# UNITED STATES PATENT AND TRADEMARK OFFICE

APPLICATION NO.	FILING DATE	FIRST NAMED INVENTOR	ATTORNEY DOCKET NO.	CONFIRMATION NO.
10/663,723	09/17/2003	Yasuhiro Shiraki	402785/FUKAMI	2240
23548	7590	05/04/2005	EXAMINER	
LEYDIG VOIT & MAYER, LTD 700 THIRTEENTH ST. NW SUITE 300 WASHINGTON, DC 20005-3960			PATEL, ISHWARBHAI B	
			ART UNIT	PAPER NUMBER
			2841

**Office Action Summary**

FIG. 8

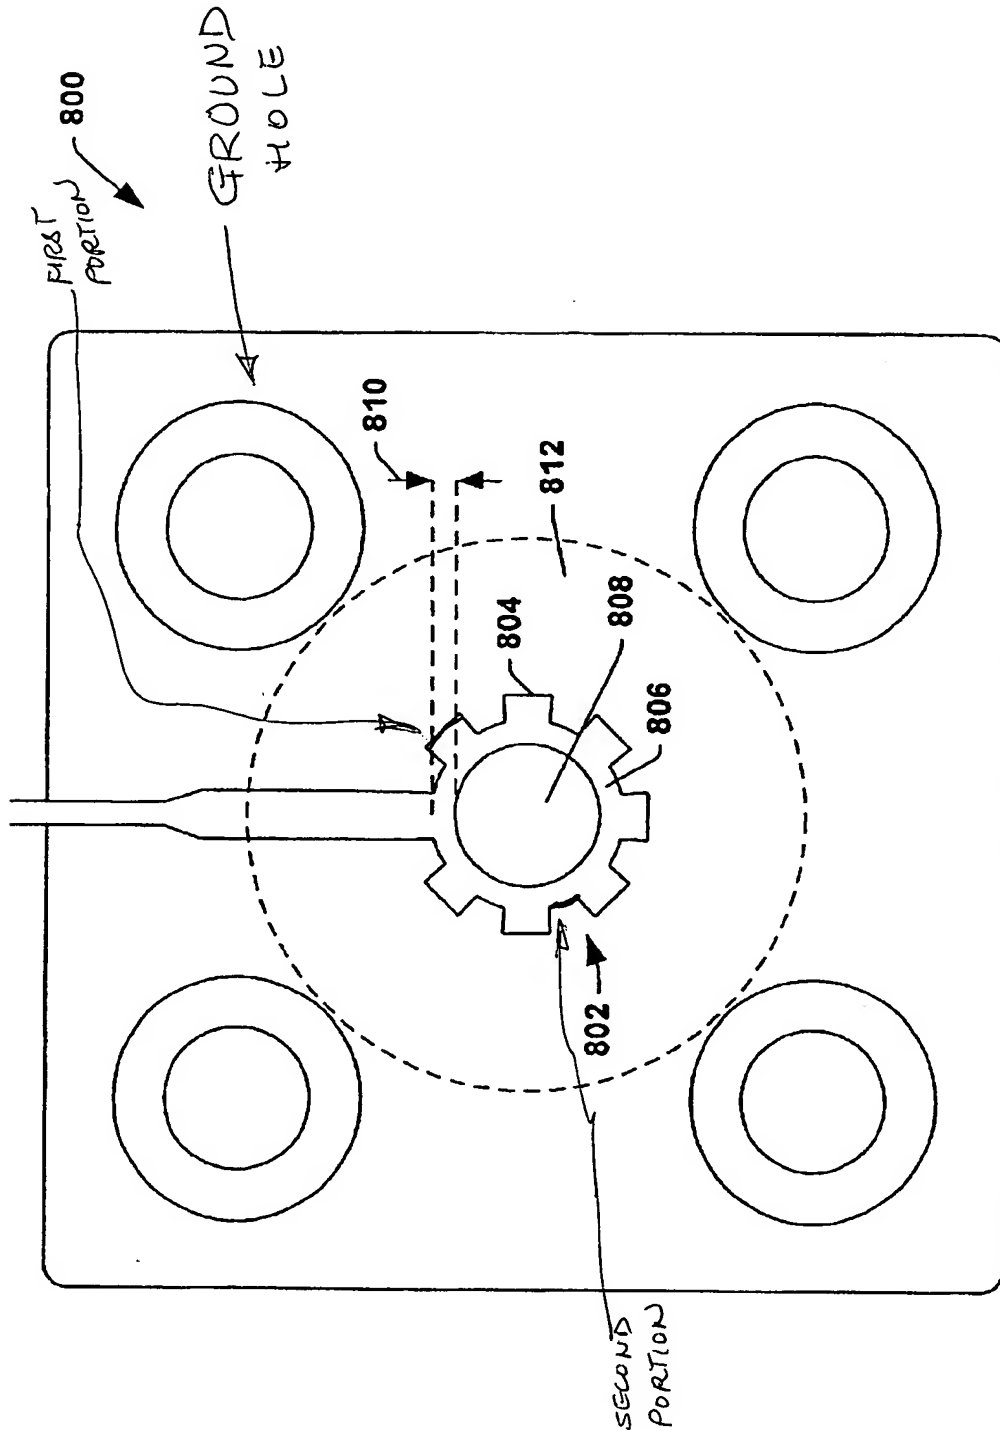
**Regarding claim 1**, Kistner, in figure 4 and 8, discloses multi-layer printed board comprising a plurality of signal layers (top layer with signal pad 418 and bottom layer),

each signal layer including a signal line (signal line as shown in figure 8, shown as element 276 in figure 2), a through-hole (404) electrically interconnecting the signal lines of said plurality of signal layers, and a ground through-hole (408) electrically interconnecting one of a plurality of ground layers (416) and a plurality of power supply layers of said multi-layer printed board, wherein said signal layer includes a land (land connected with the signal trace as shown in figure 8) connecting said through-hole to said signal line; said land has an external periphery with a first portion (portion with a periphery of projection 804, as marked on figure 8, in appendix "A") and extending further from a center of the land than any other portion of the external periphery and a second portion (second portion as marked on figure 8 in appendix "A") having a second radius (radius of disc portion 806) and extending a shorter distance from the center of the land than said first portion and a portion of the external periphery of said land opposite the ground through-hole (ground hole as marked on figure 8 in appendix "A") closest to the center of said land is the second portion (second portion as marked on figure 8 in appendix "A").
